ADDENDUM #3

Project	Holy Family Catholic Elementary School	Project No.	2325
Location	1420 Grosvenor Street, Oakville, ON	Date of Issue	2024 04 09
Owner	Halton Catholic District School Board	File	2325/7.1.3

RE: Holy Family Catholic Elementary School
Renovations
Oakville, ON

ADDENDUM 02

Drawing Title
GROUND FLOOR PLAN RENOVATION PHASE 1

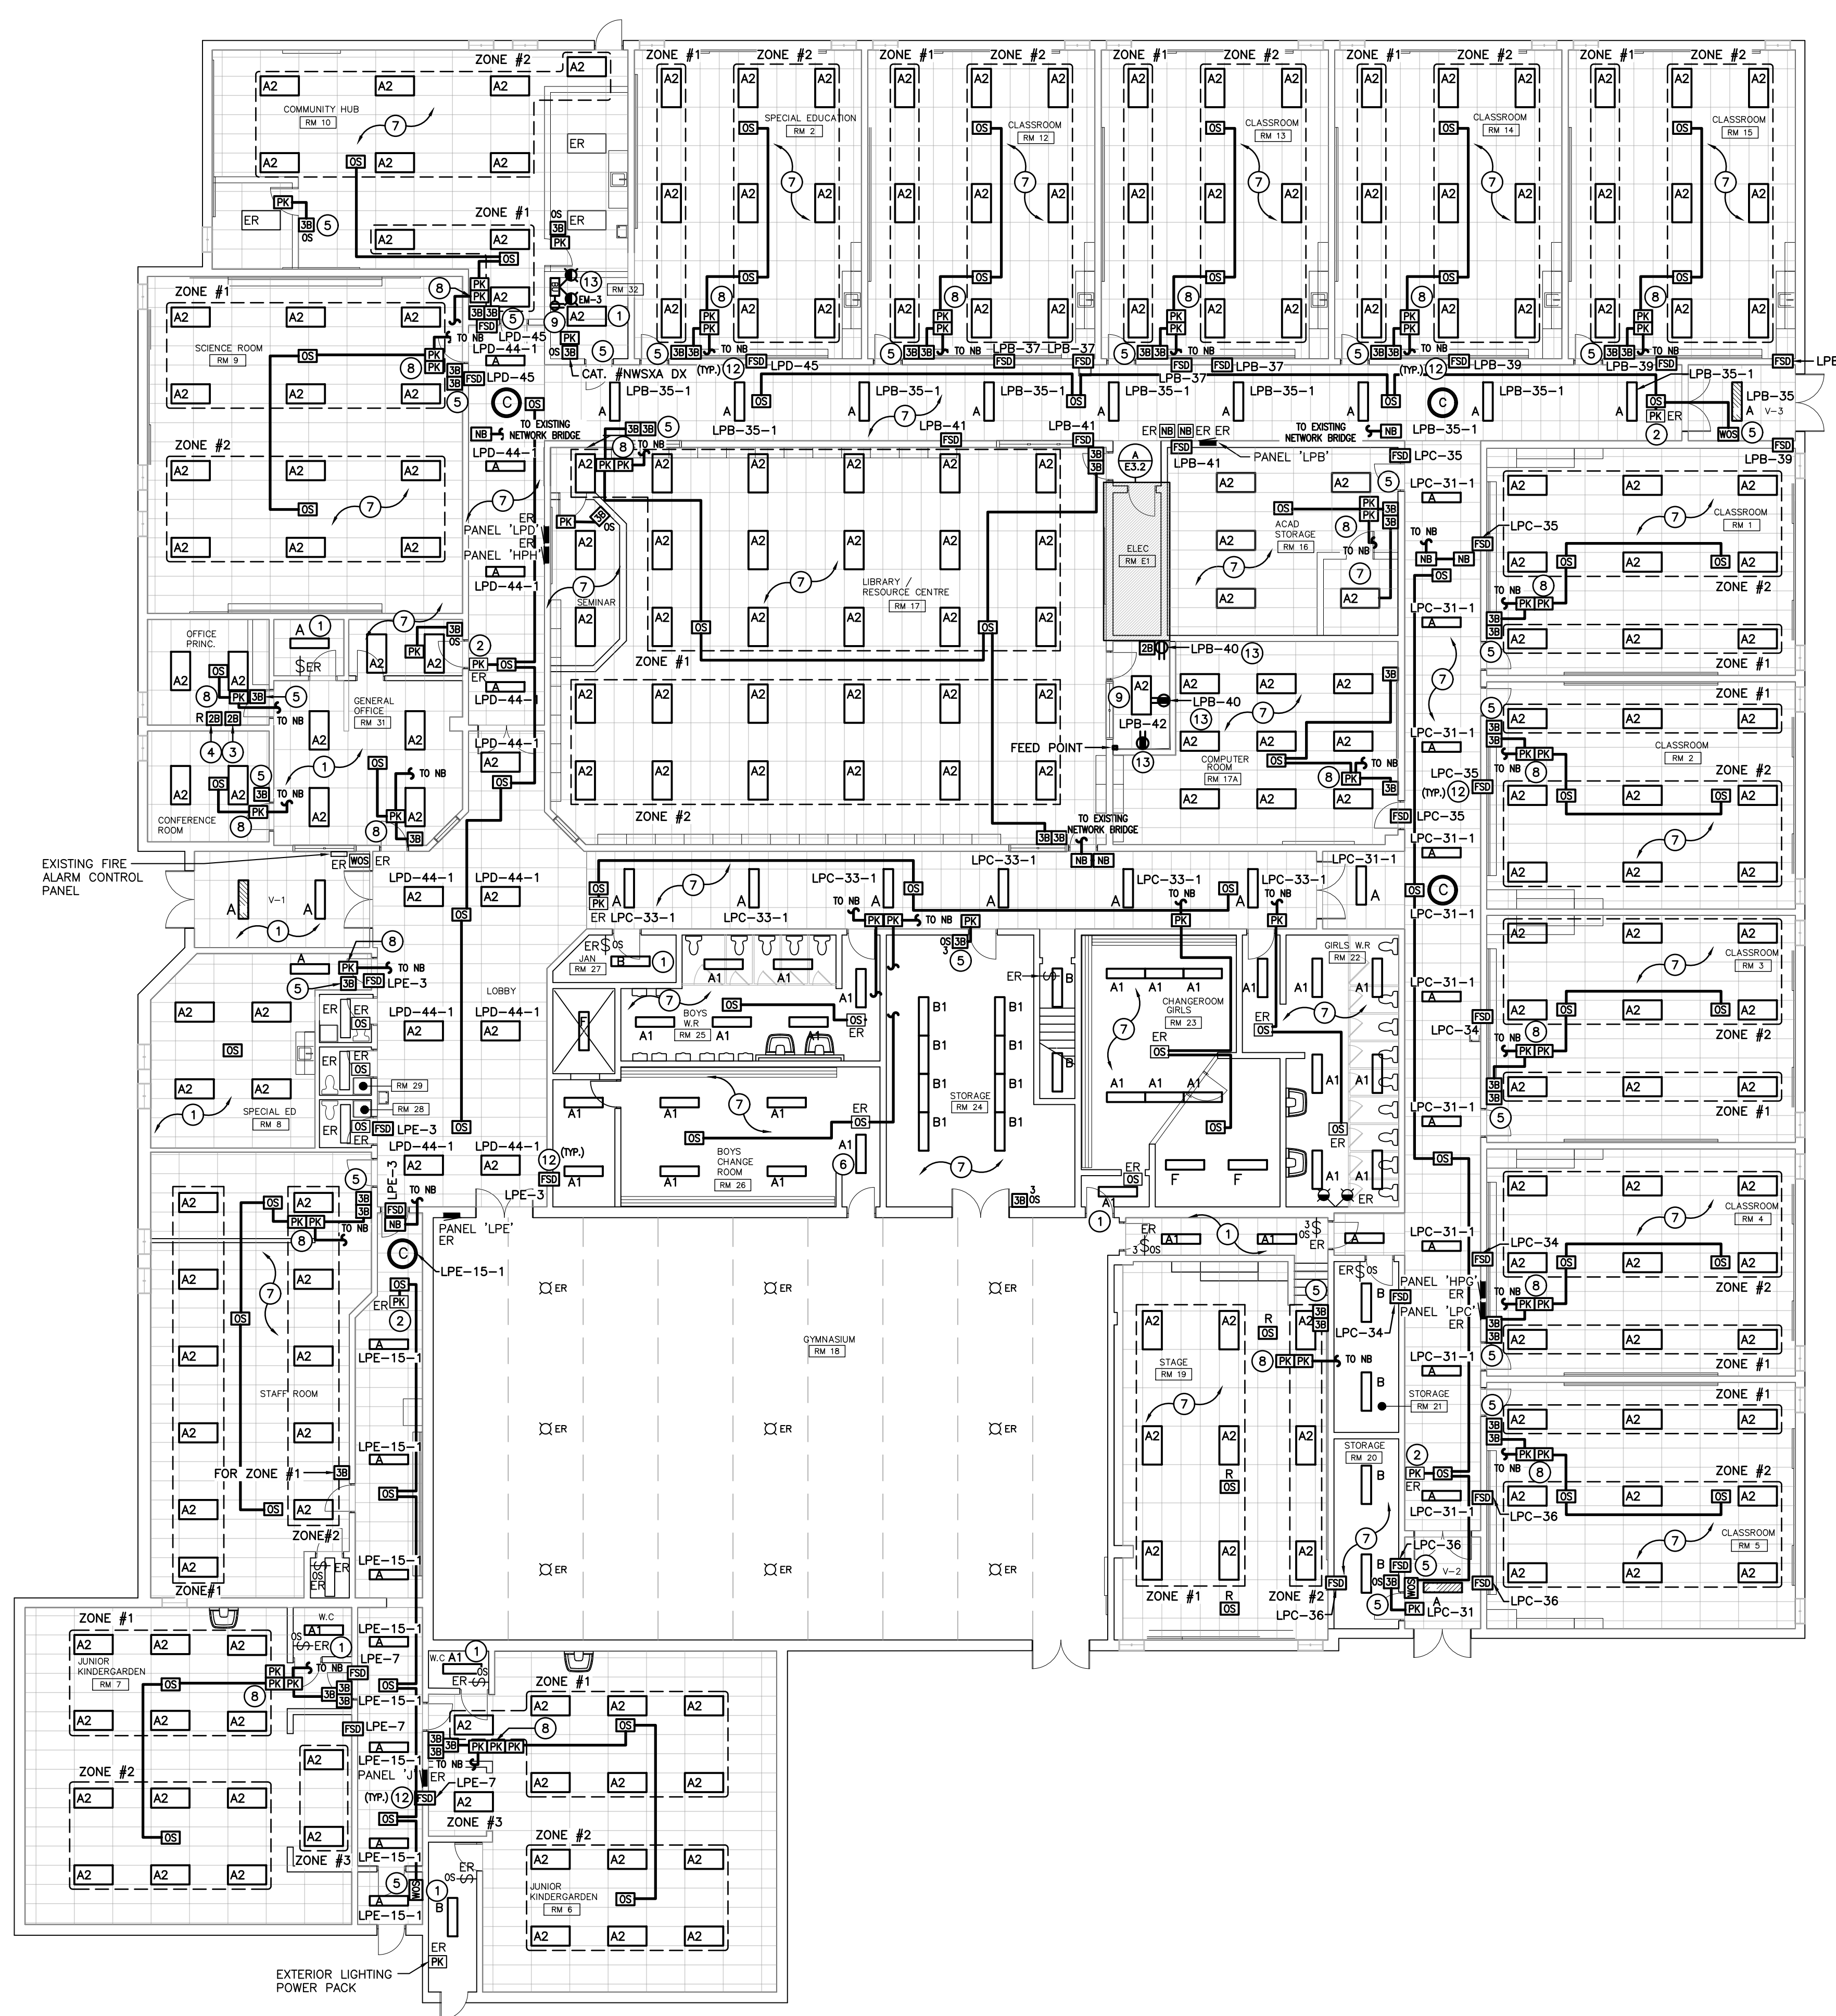
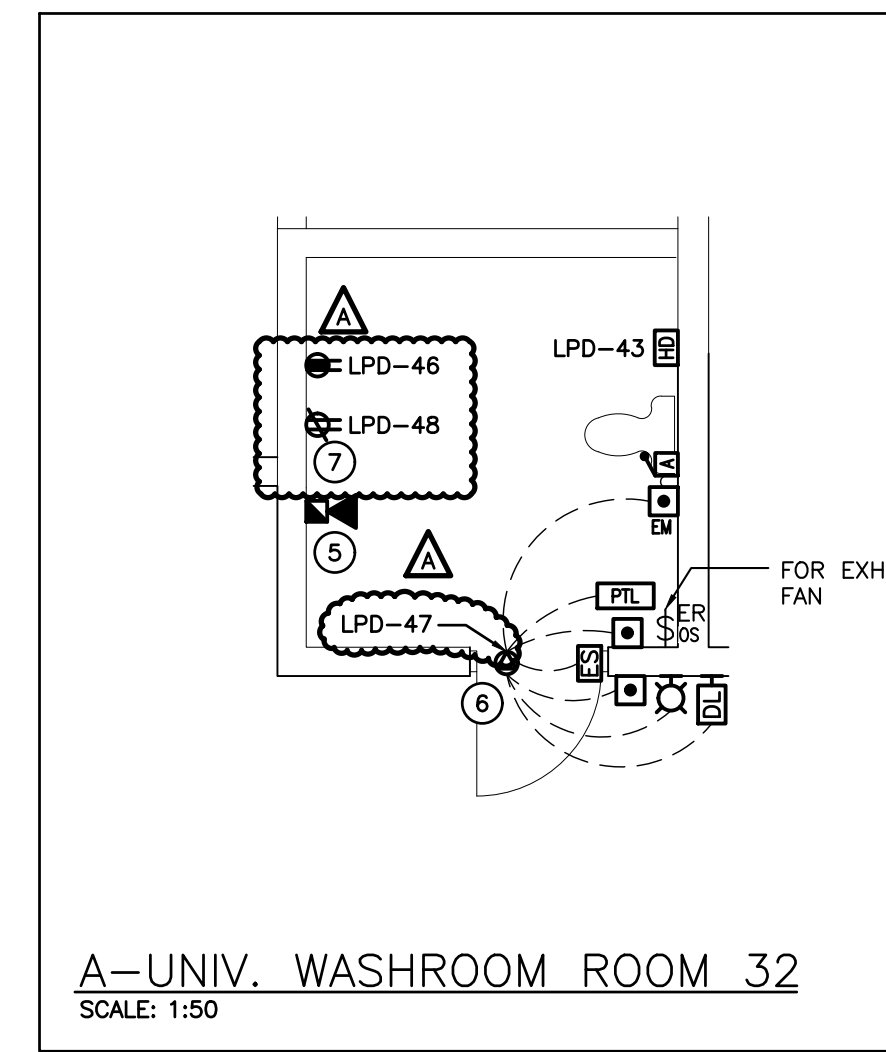
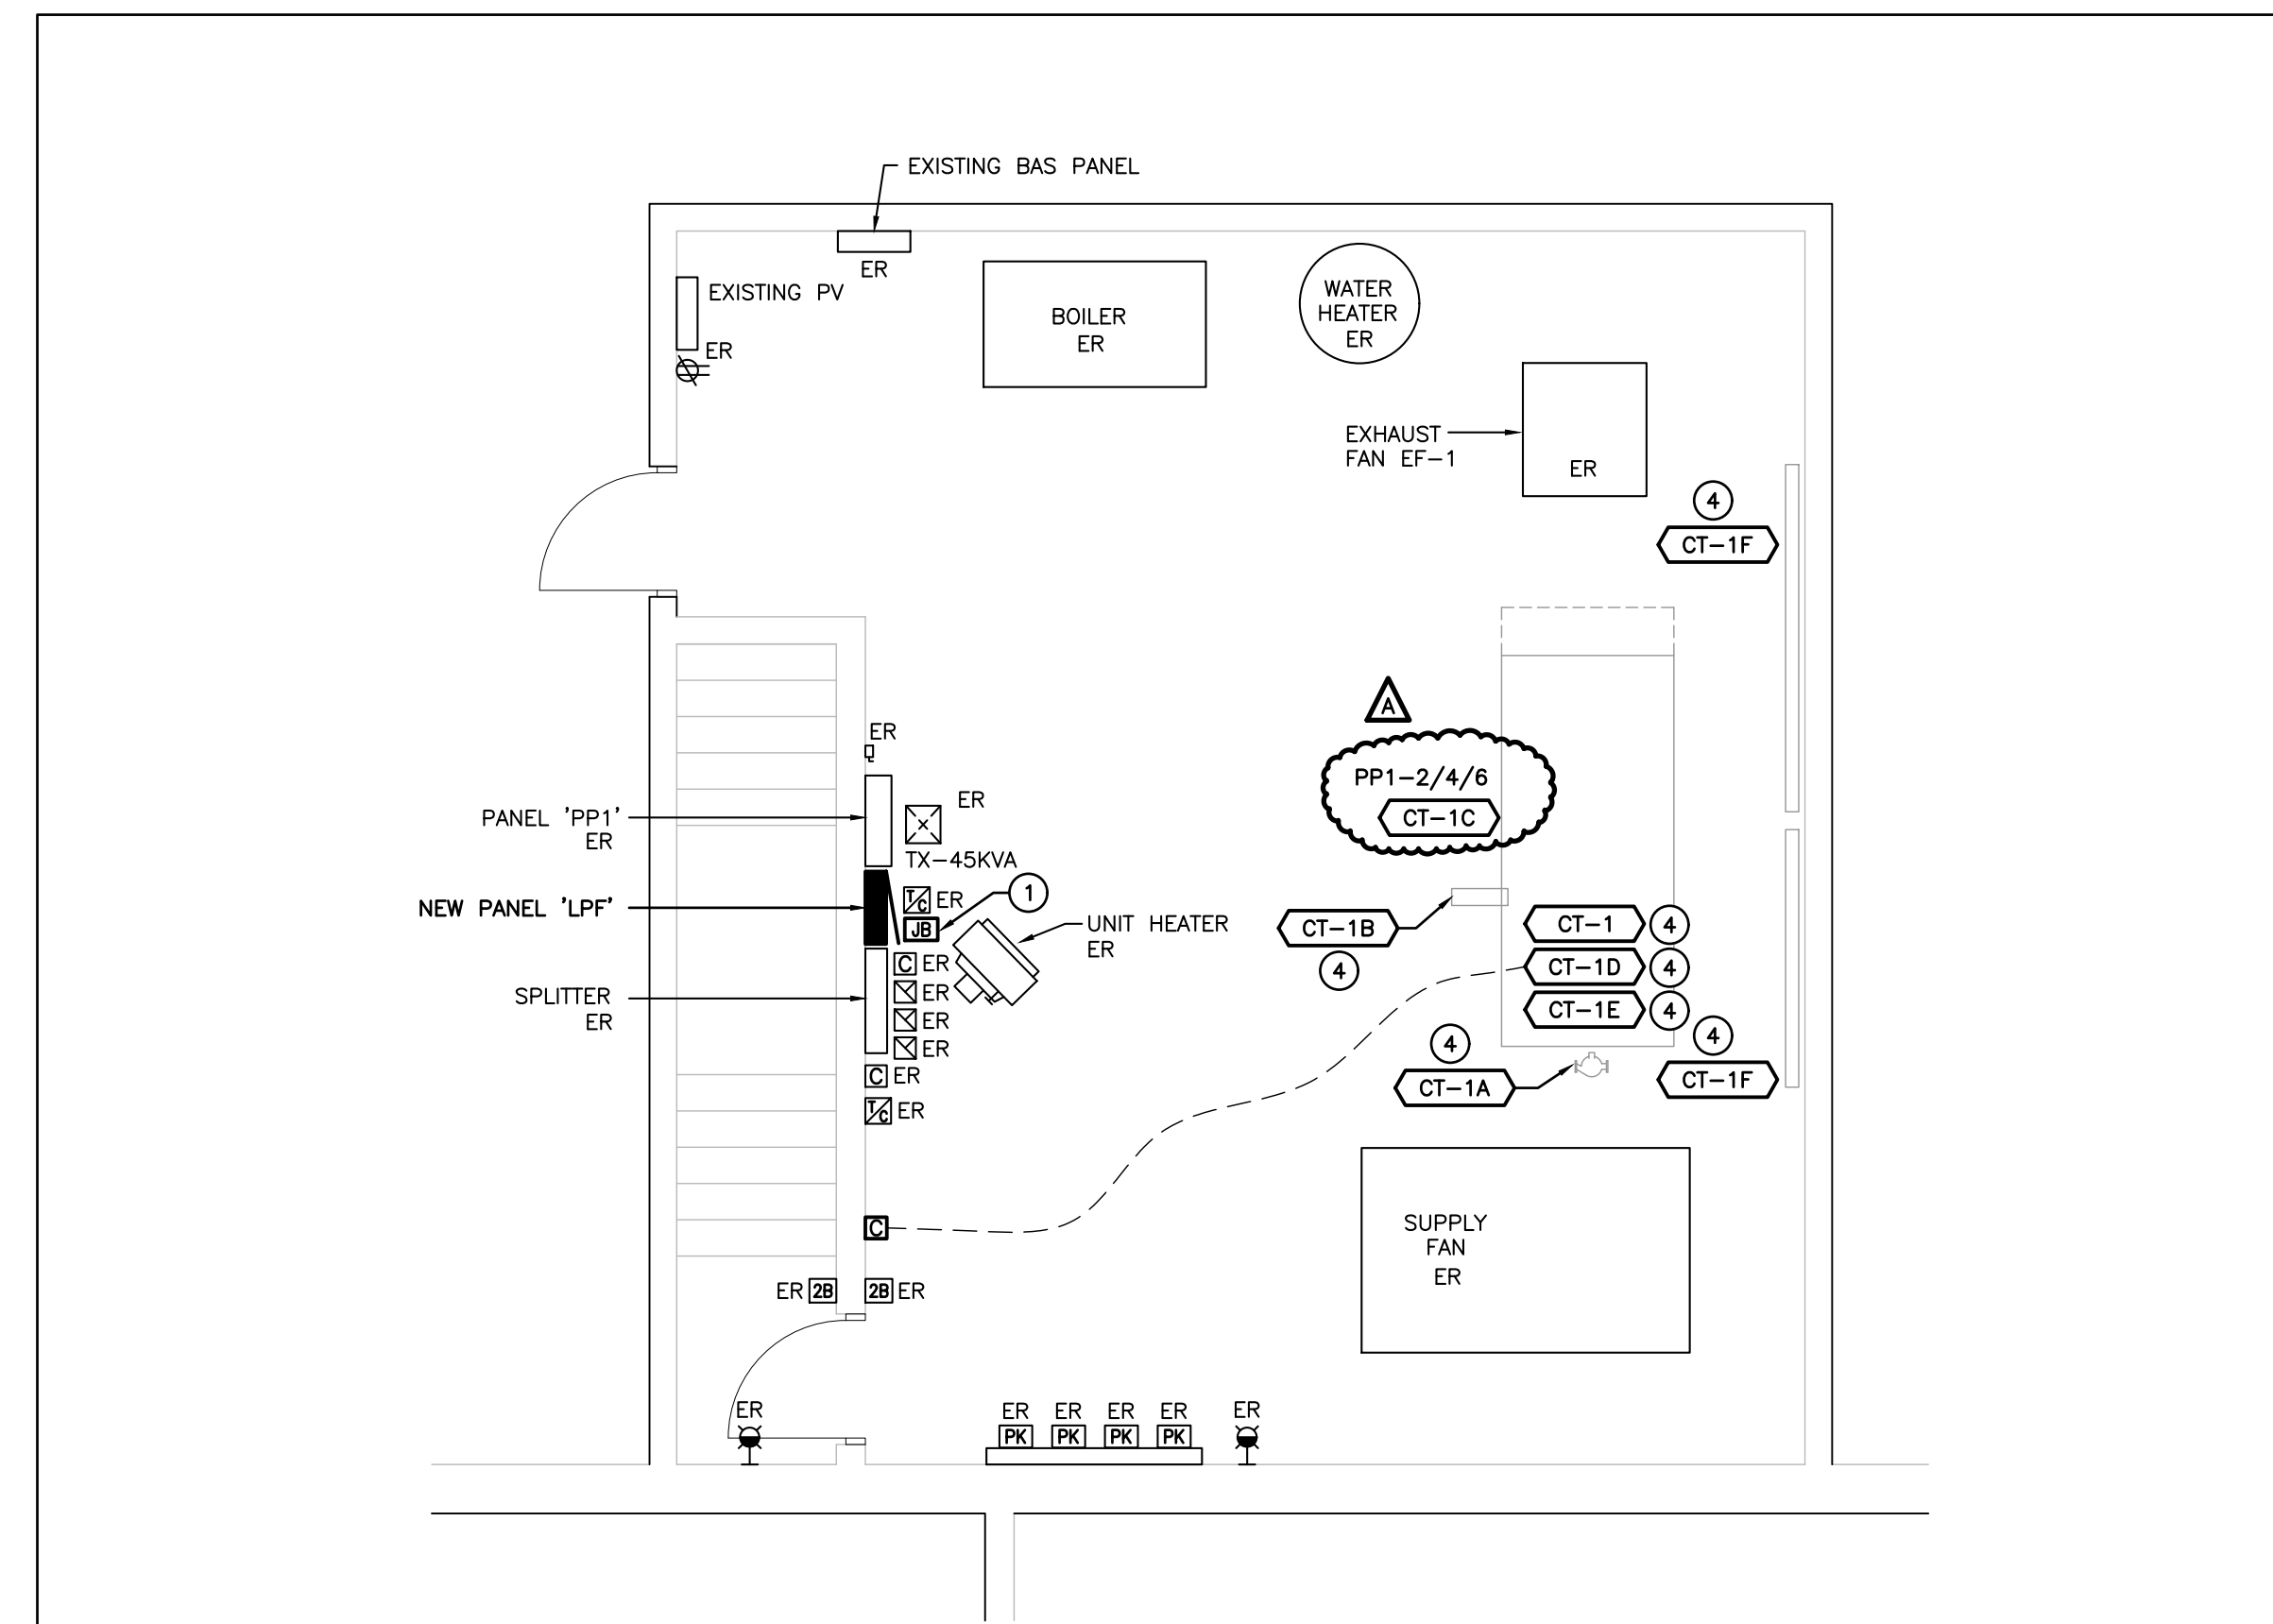
8.0 Reference Attached Reissued Drawing E3.1

- .1 Provide receptacle for change table and circuit within Universal Washroom '32' as shown. Revise panel schedule to suit.
- .2 Add circuit for Universal Washroom door operator as shown. Revise panel schedule to suit.
- .3 Provide receptacle for future lift and circuit within Universal Washroom '32' as shown. Revise panel schedule to suit.
- .4 Remove note bubble #2 on Mechanical Item "CT-1C" within mechanical penthouse. Provide circuit as shown.
